Work Order ID 140979

Item Name: Strut

APICAL INDUSTRIES, INC.	ENGINEERING CHANGE NOTICE NO. 04274				SHEET 1 OF 1	
	DWG NO. 646.3500	REV: NC	PREPARED BY J. SOTO	DATE: 12/02/2013	EFFECT ON DWG ☐ INC. ☒ UNINC.	
	DWG TITLE: STRUT					
	APPROVED BY: ENGR <i>[Signature]</i>	MFG <i>[Signature]</i>	QC <i>[Signature]</i>	EFF. NEXT ORDER		
TRANSACTION CODES (TC): A-ADD R-REVISE C-CREATE D-DELETE	REASON: REVISED DELTA NOTE 1 & 2.

ENGINEERING CHANGE NOTIC. NO. 02440		SHEET 1 OF 1	
DWG NO. 646.3500	REV: NC	PREPARED BY S. HUFF	DATE 06/08/09
DWG TITLE: STRUT		EFFECT ON DWG ☐ INC. ☒ UNINC.	
APPROVED BY: ENGR <i>[Signature]</i>	MFG <i>[Signature]</i>	QC <i>[Signature]</i>	EFFECT: CURRENT ORDER AND STOCK
REASON: REVISED GEOMETRY TO ACCOMMODATE NEW EXISTING AIRCRAFT PROVISIONS

SHEET 1, ZONE A1 IS:

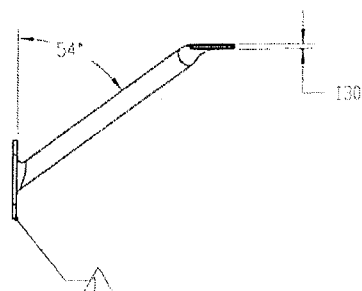
- 1 MATERIAL: AISI 304/ 316 SS SHEET .062 THK
(REF DART SPEC. M304S16GA)
- 2 MATERIAL: AISI 304/316 SS 0.500 OD X 0.049 WALL
(REF DART SPEC. M304TR0.500W0.049)
ENSURE SEAMLESS TUBE IS USED
- 3 FINISH: HARD ANODIZE IAW MIL-A-8625 TYPE III, CLASS 2
COLOR BLACK;
CARDINAL 4860-50 PRETREATMENT PRIMER
PRIME IAW MIL-P-23377J TYPE I CLASS N
4. DEBURR AND BREAK ALL SHARP EDGES
5. WELDS IAW MIL-STD-2219.
TIG WELD WITH FILLER ROD

SHEET 2 IS:

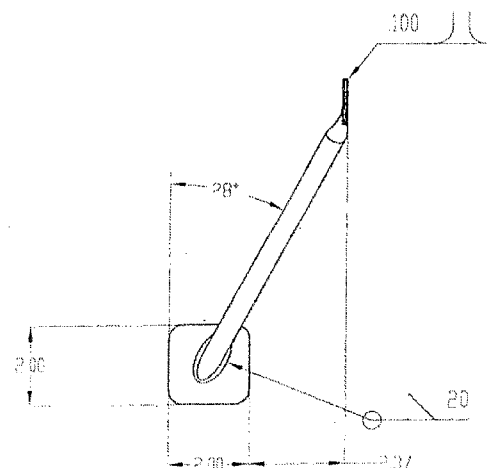
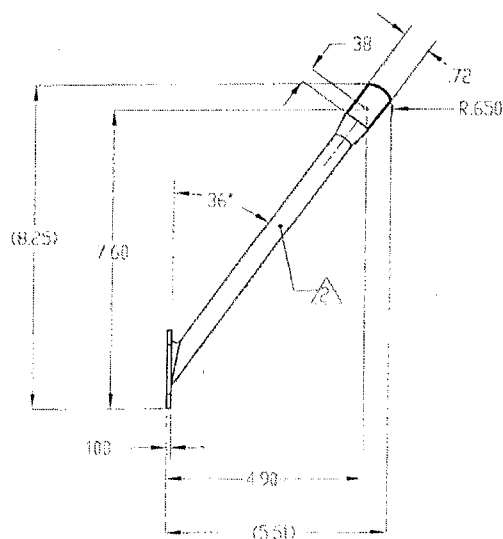
646.3512 SHOWS
646.3513 OPPOSITE
